Date	Group	No.	Release	Page
5.2012	255	022	02	1(6)

Engine VGT Actuator and TSS Sensor Connector, Relocation VN, VHD, VAH D13H

SP 255-022, Engine VGT Actuator and TSS Sensor Connector Relocation

W2072567

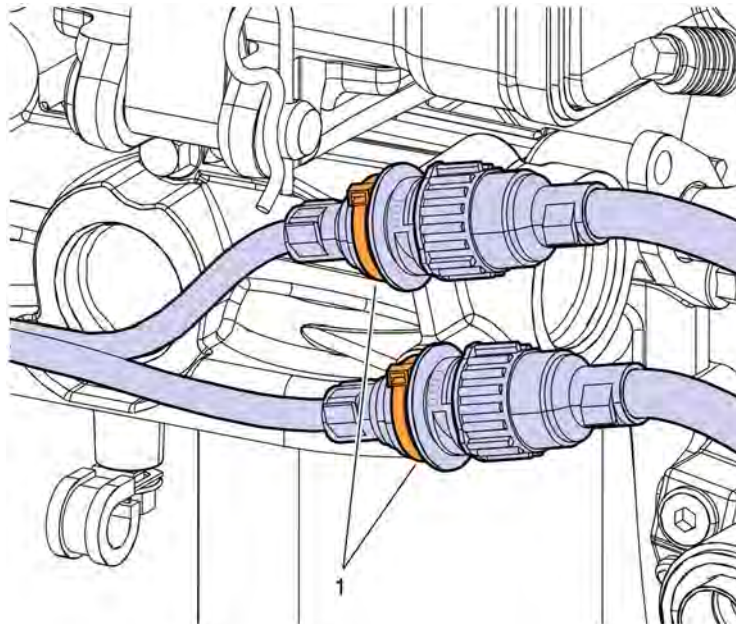
A new campaign is available to prevent engine diagnostic trouble codes (DTCs) and missing signal from the Engine Variable Geometry Turbocharger Actuator (Engine VGT Actuator) on VOLVO D13 US2010 engines with a Mechanical transmission. This condition is caused by fretting of the connector pins in the engine VGT actuator connector. Relocation of the engine VGT actuator connector and a new mounting arrangement has been developed to eliminate this condition. See the table below for the list of parts required for this campaign.

W2072331

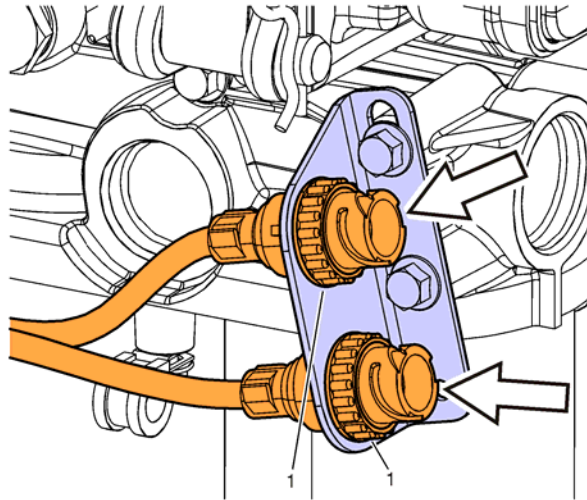
- 5 Remove the engine VGT actuator and TSS sensor connectors from the mounting bracket.

Note: Discard the attachment ring/nut (Item 1).

W2072332

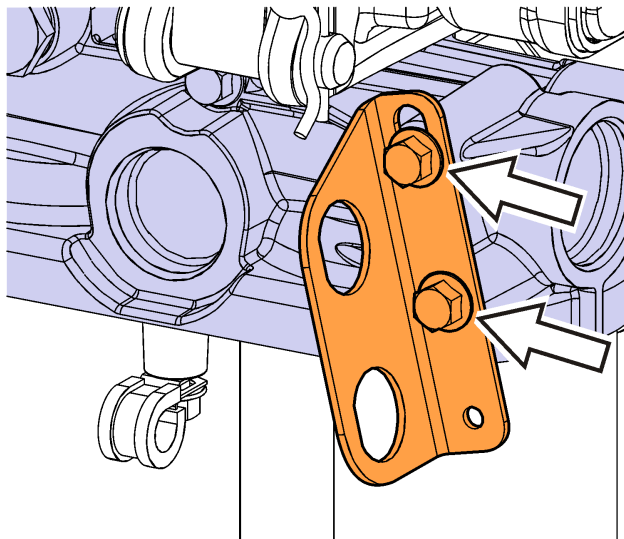
- 6 Remove the connector mounting bracket from oil filter housing.

Note: Discard the mounting bracket.

W2072325

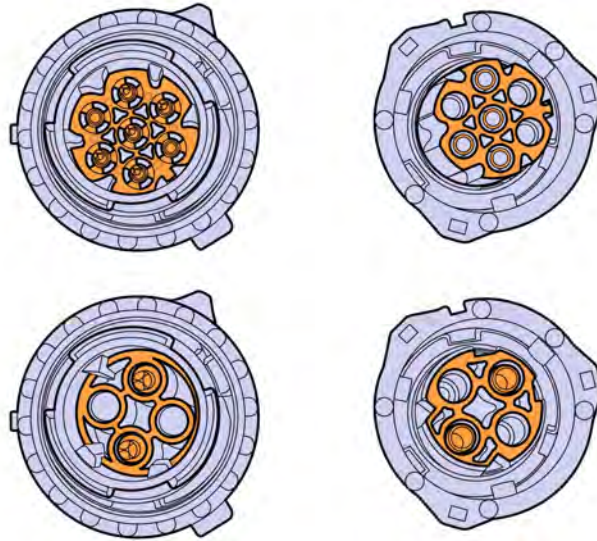
- 7 Inspect connectors for green/brown dust on the pins or sockets.

Note: If green/brown dust is present in the areas highlighted in the figure below, clean the male and female engine VGT actuator and TSS sensor connectors with approved electrical solvent. Allow the connectors to thoroughly dry before assembly.

Note: If the Engine VGT Actuator Connector pins show signs of wear, replace the pins per "Engine VGT Actuator Connector Pin, Replacement" Field Service Bulletin PV729-FSB255-024_V (USA53614).

W2072333

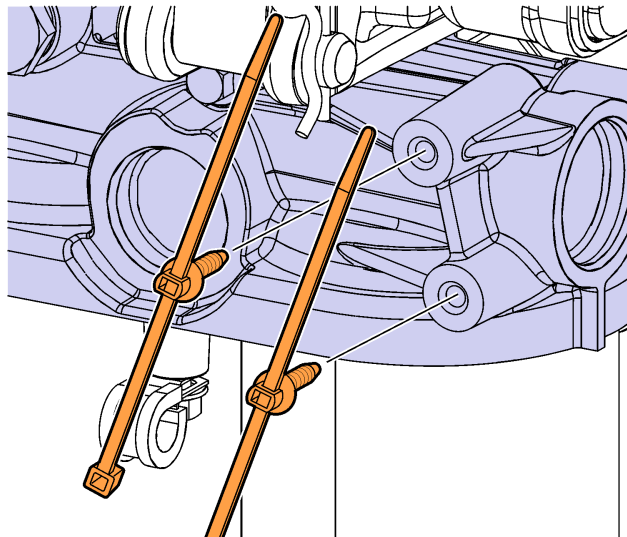
- 8 Install the push-in cable ties (part number 980881) into the M8 threaded holes in the oil filter housing.

Note: Ensure the push-in cable tie flanges are tightly secured against the M8 threaded holes in the oil filter housing.

W2072334

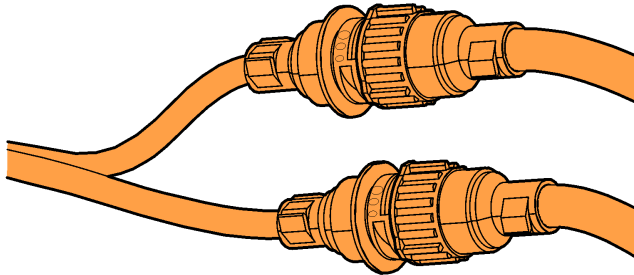
9 Connect and lock the engine VGT actuator and TSS sensor connectors together.

W2072335

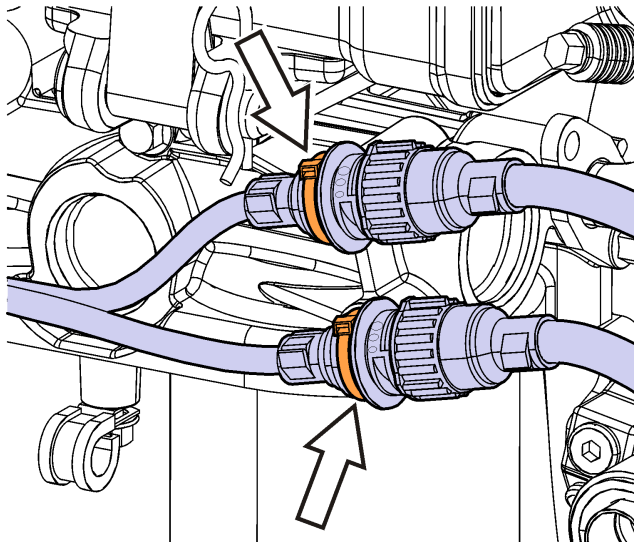
10 Secure both connectors with the push-in cable ties.

Note: Ensure the cable tie is in the end groove between connector flange and back shell as shown in figure below.
